## Bulletin

**Application:** GM 4L60E 1993-Up

**Subject:** Valve Body Gaskets

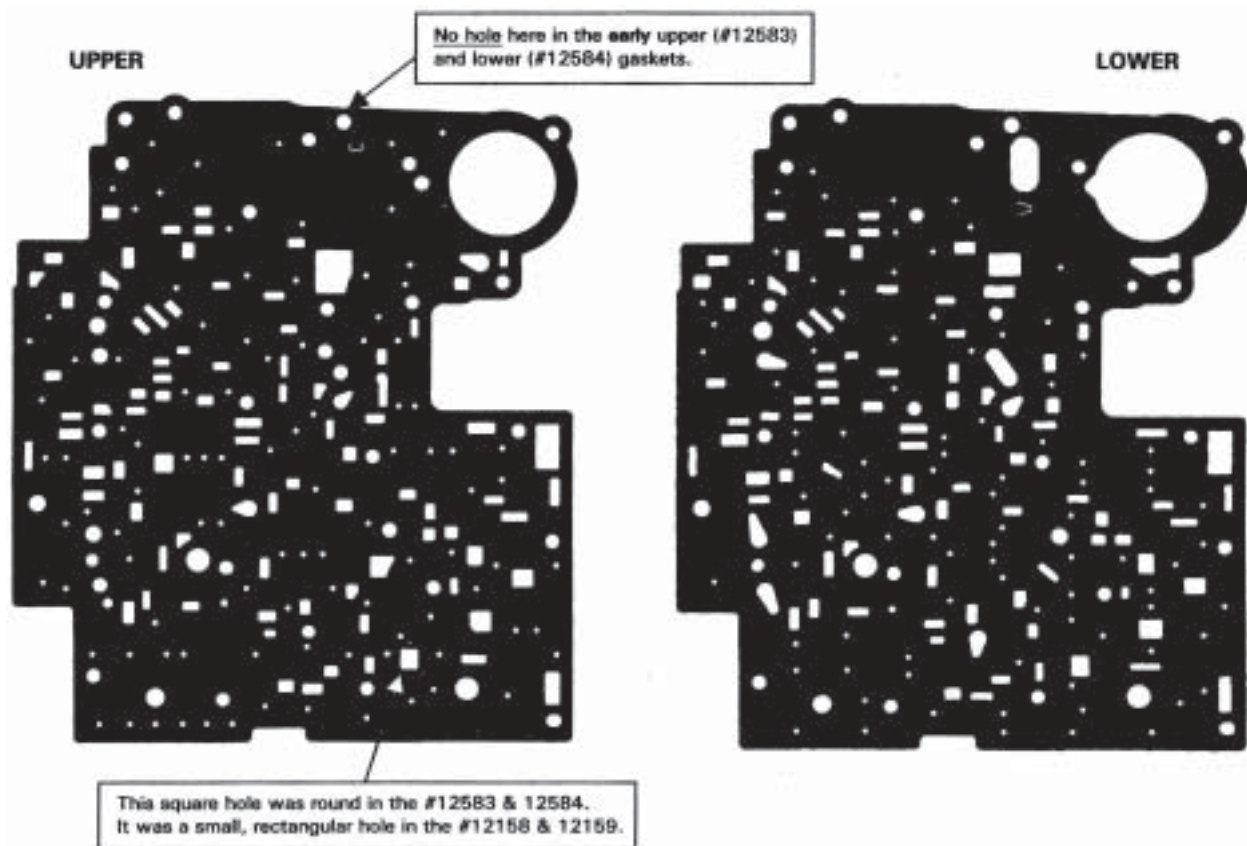
TransTec has engineered a set of combo valve body gaskets for the THM 4L60E. The new gaskets will fit from 1993 to 2001 and eliminate the possibility for confusion or using the wrong gasket. All gasket sets and overhaul kits with a date code of B02 and later contain only the new, **combo** valve body gaskets.

**Upper Gasket:** TransTec #12316 replaces: #12583 (OE #8681603) early, and #12158 (OE #24211921) late.

**Lower Gasket:** TransTec #12319 replaces: #12584 (OE #8681806) early, and #12159 (OE #24211920) late.
